**TOWN OF MOUNTAIN VILLAGE
REGULAR DESIGN REVIEW BOARD MEETING
AGENDA**

THURSDAY DECEMBER 3, 2020 10:00 AM

4.	10:10	60	Ward Applicant	Quasi-Judicial	Consideration of a Design Review: Initial Architecture Review for a new single-family residence on Lots 517 & 518 (518R) 146 Russell Drive, pursuant to CDC Section 17.4.11

1 NORTH ELEVATION - ROOF HEIGHT ANALYSIS
1/8" = 1'-0"

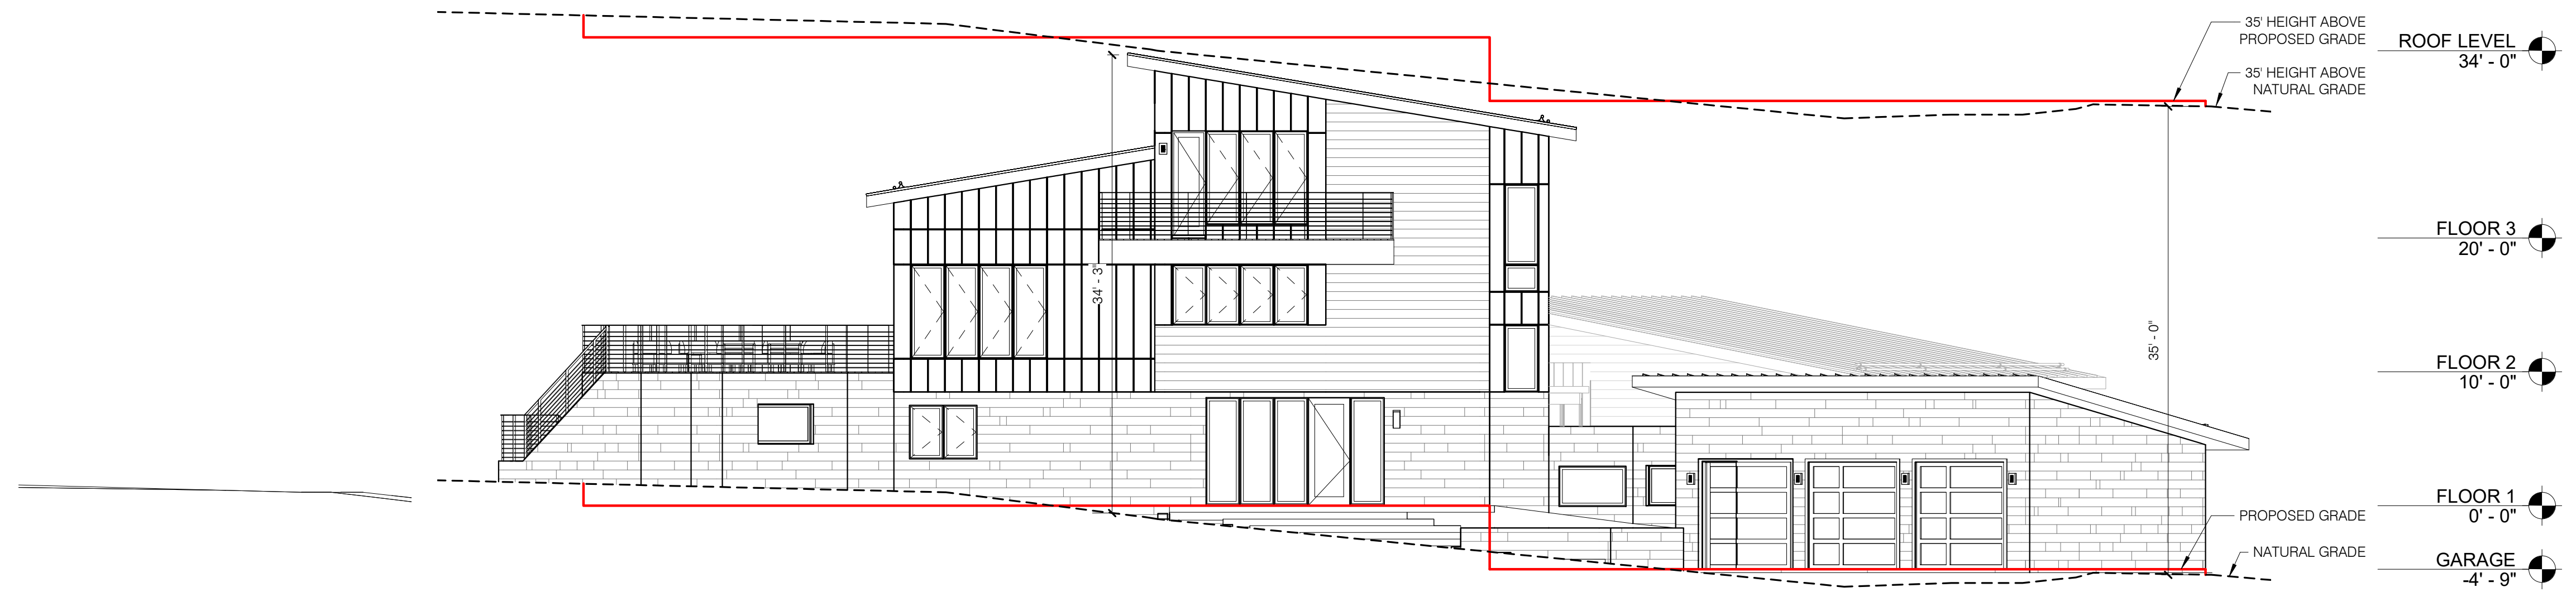
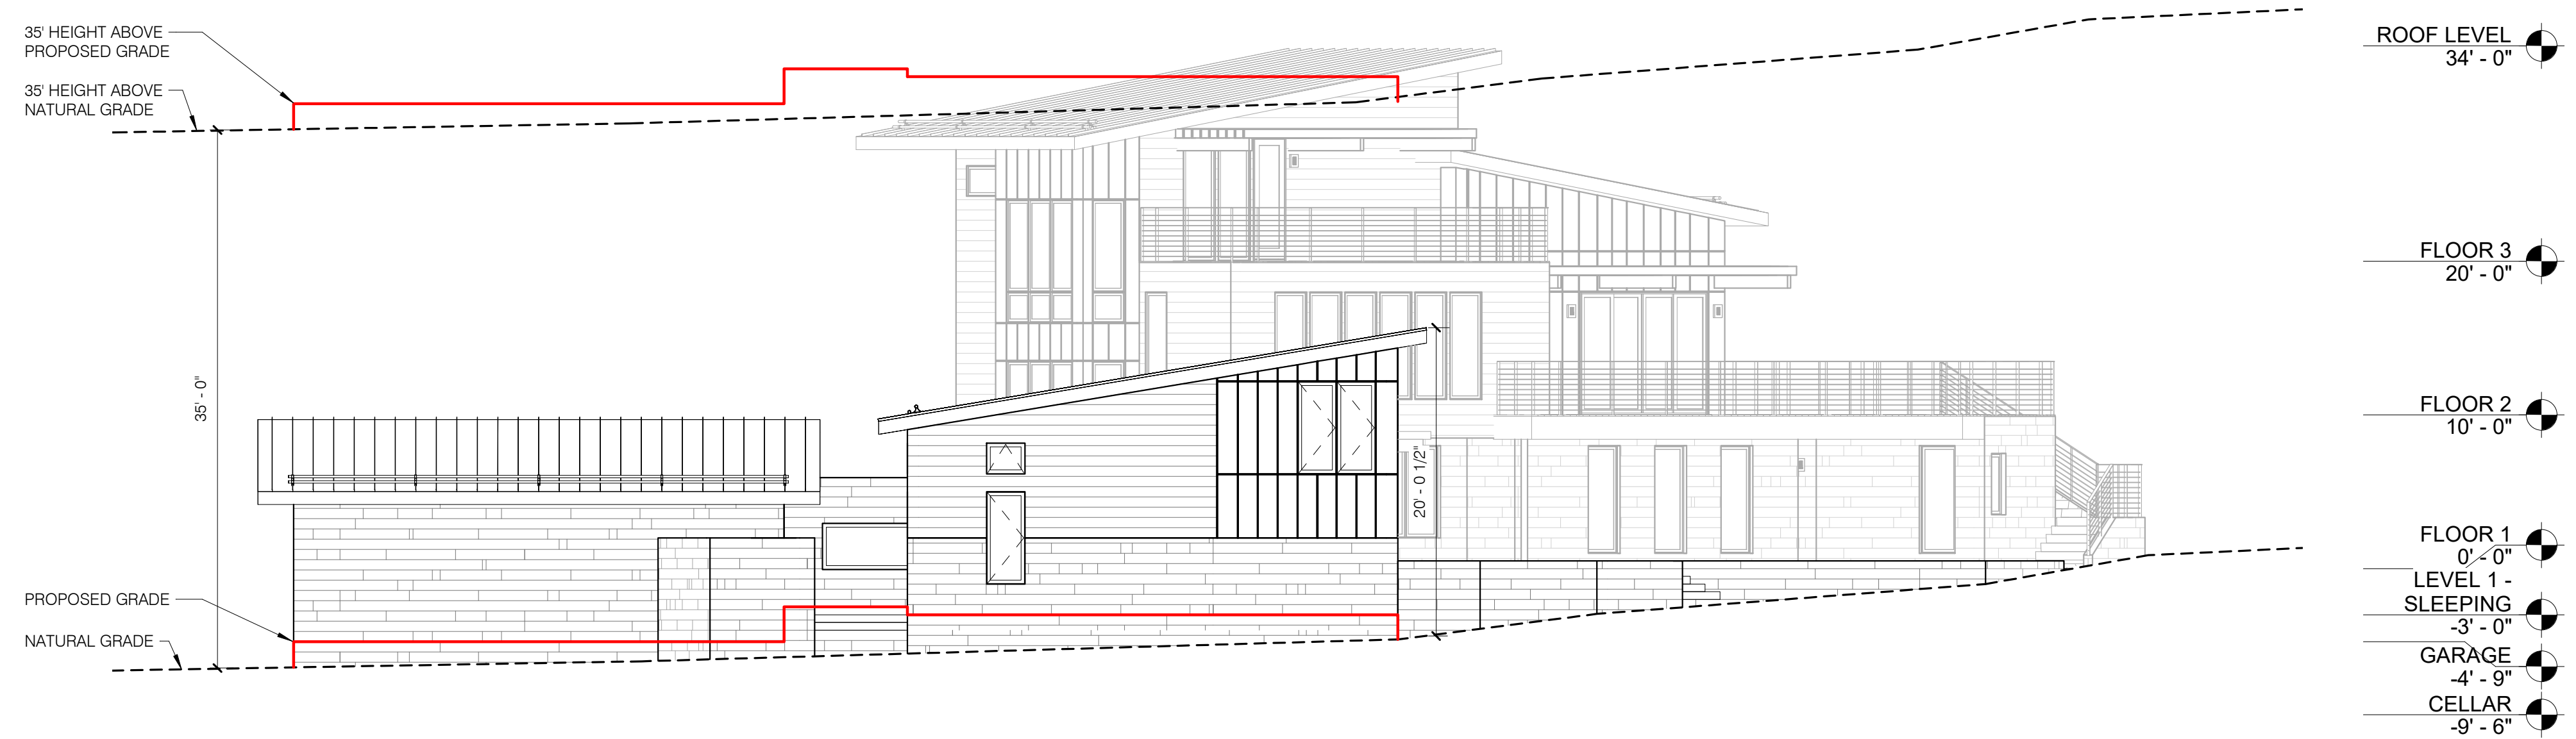
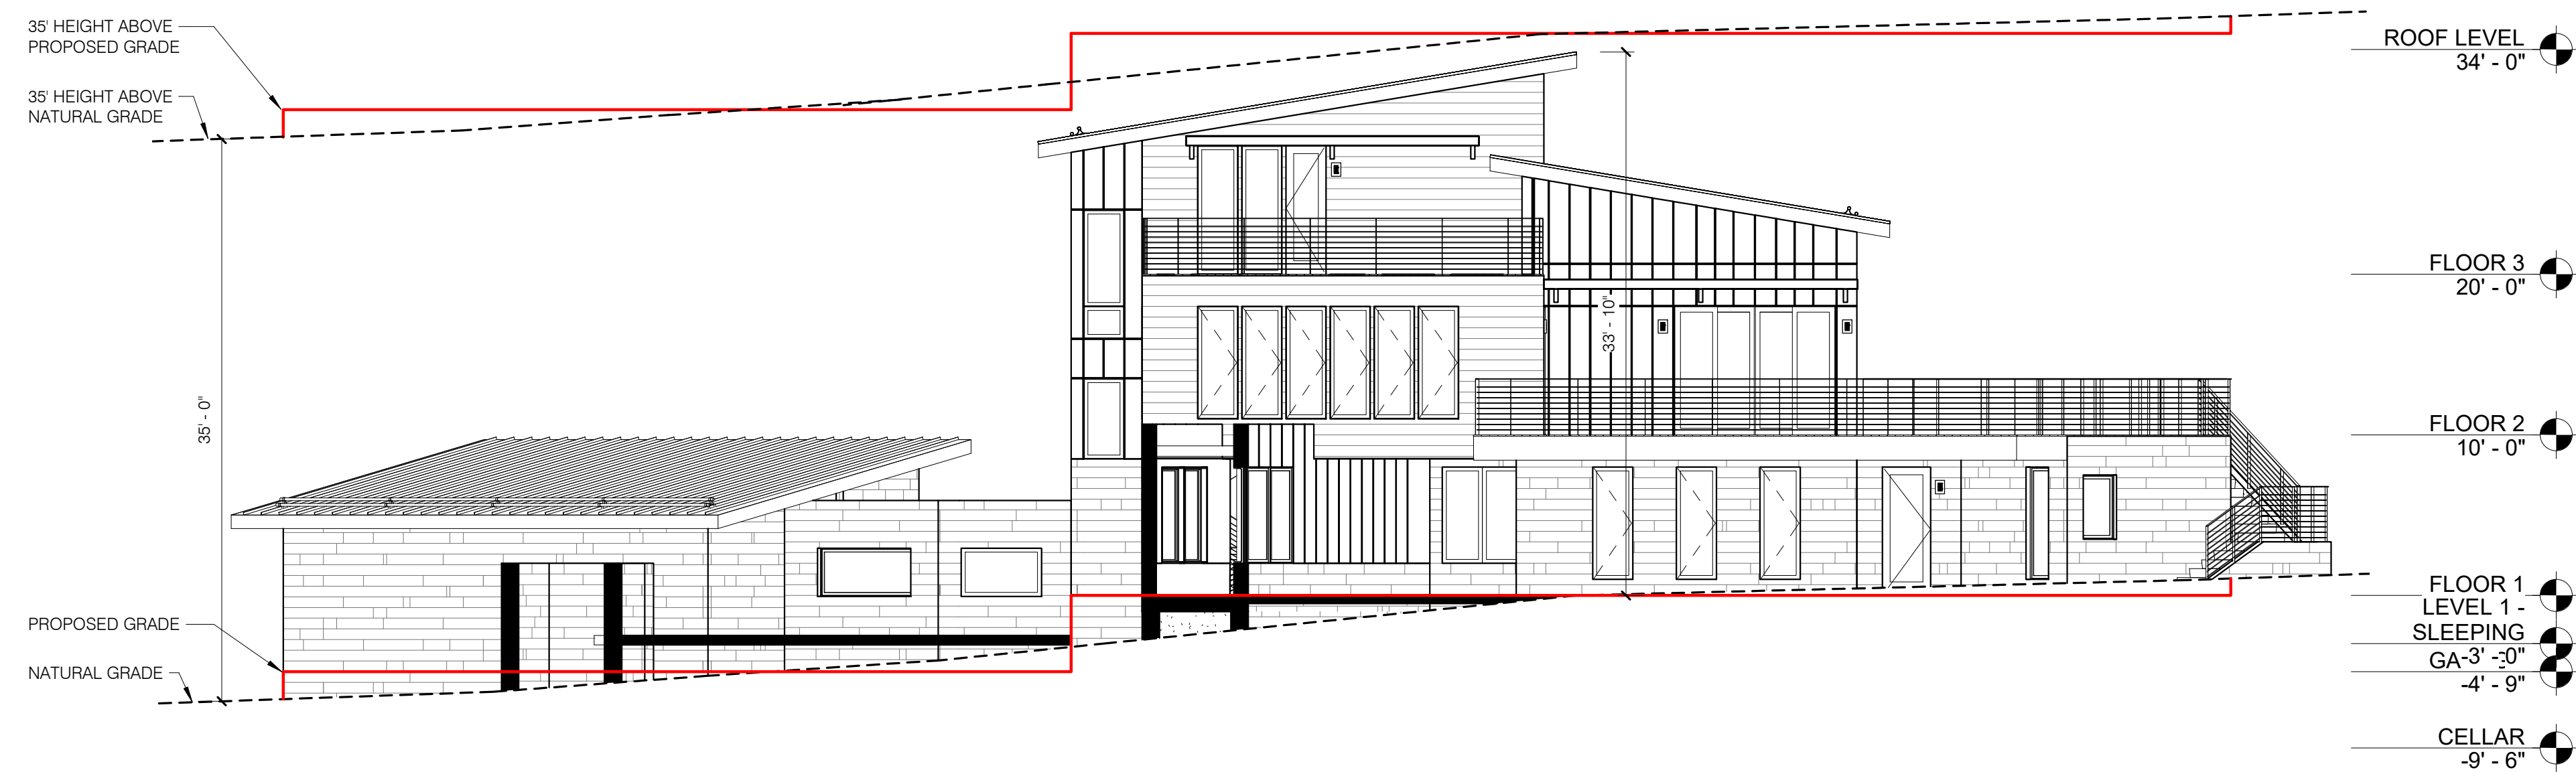
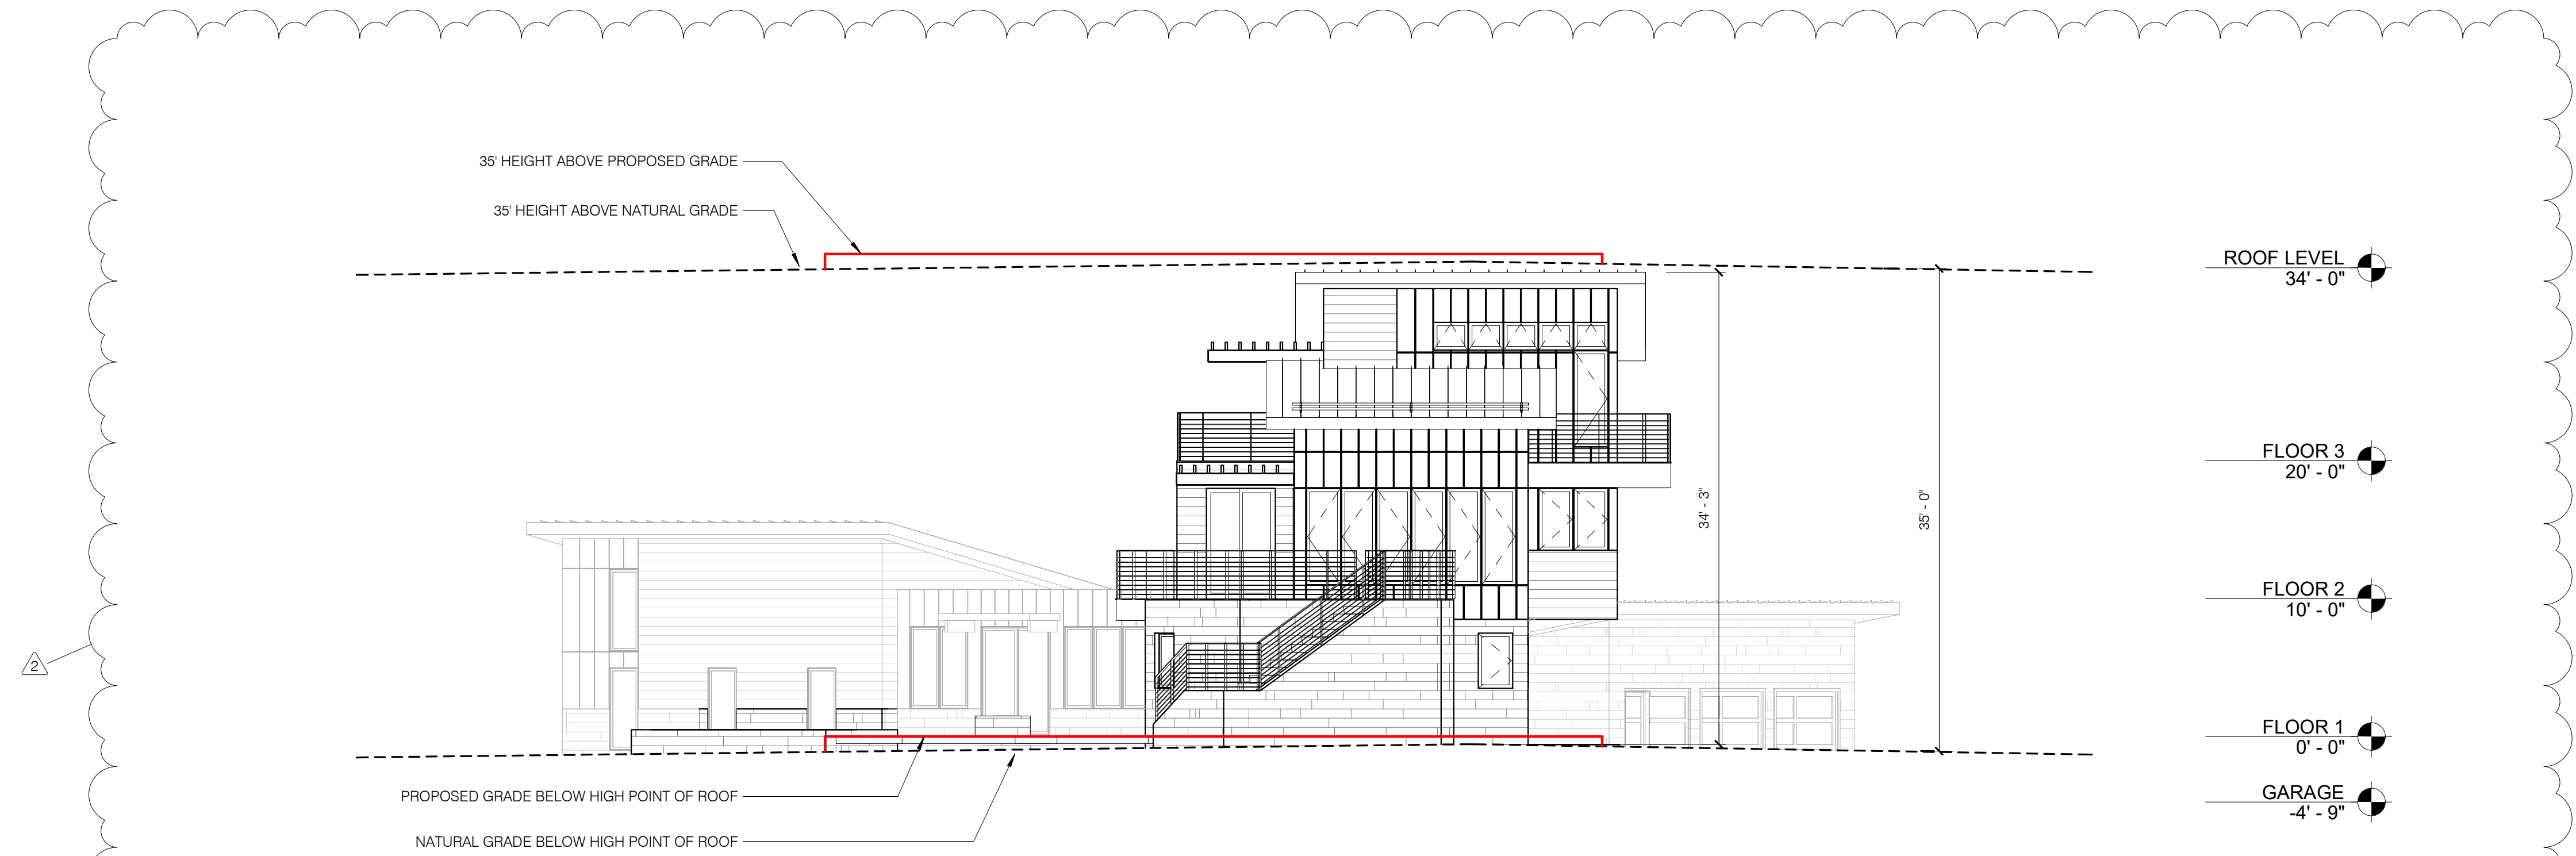
Staff: As part of this application, the applicant has provided both a Maximum Building Height and Average Building Height analysis. Based on the heights provided, the applicant is 34'3" feet from the highest ridge to the grade below in the tallest "pod" of the home. The other "pods" are significantly lower than this. Staff finds that given the data provided, it appears that the home meets both the height requirements for Maximum Heights and Average Max Height, but this should be demonstrated with a parallel plane study for final review.
